# Consultation response on Transport for London plans for East-West superhighway phase 2

March 2015

This consultation response deals with the proposals in the phase 2 consultation on the East West Cycle Superhighway. It should be read in conjunction with the first consultation response on the majority of this cycle route.

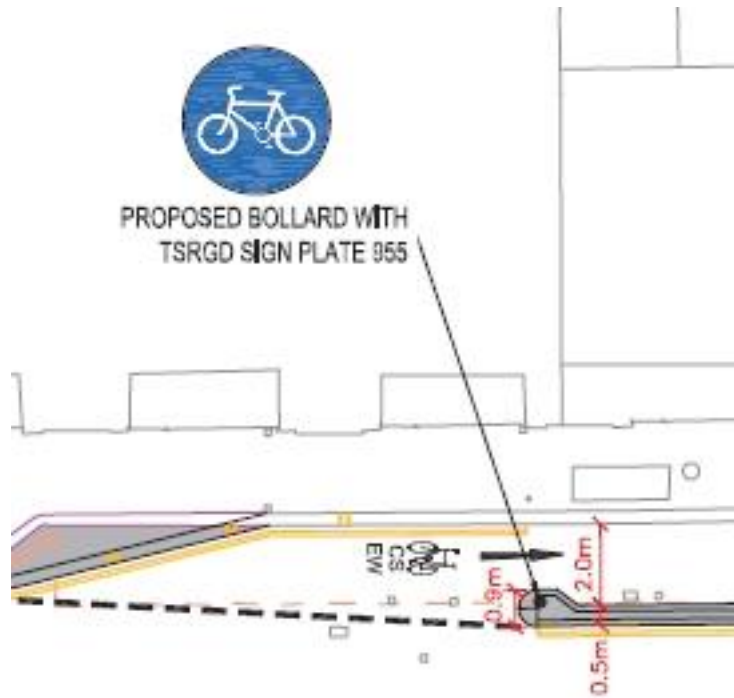
At the eastbound approach to the junction of Bayswater Road with Lancaster Terrace, there is potential conflict between cyclists proceeding straight ahead and left-turning traffic. The use of an 'Early Start' junction design on Bayswater Road is unacceptable where there is a high demand for motor traffic including buses to turn left into Lancaster Terrace. On Bayswater Road and Westbourne Terrace the early start junctions are likely to be blocked with queuing motor traffic in peak hour, eliminating any safety benefit. At Westbourne Terrace the long distance between the cyclists' stop line and the actual left turn lets fast motor traffic catch up with slow cyclists – all the motor traffic is turning left, while almost all the cyclists will be going straight on.

There needs to be a protected route for cyclists using Bayswater Road, with separate signal phasing for cyclists and motor vehicles, to eliminate the risk of left turn collisions for eastbound cyclists at Lancaster Terrace and Stanhope Terrace.
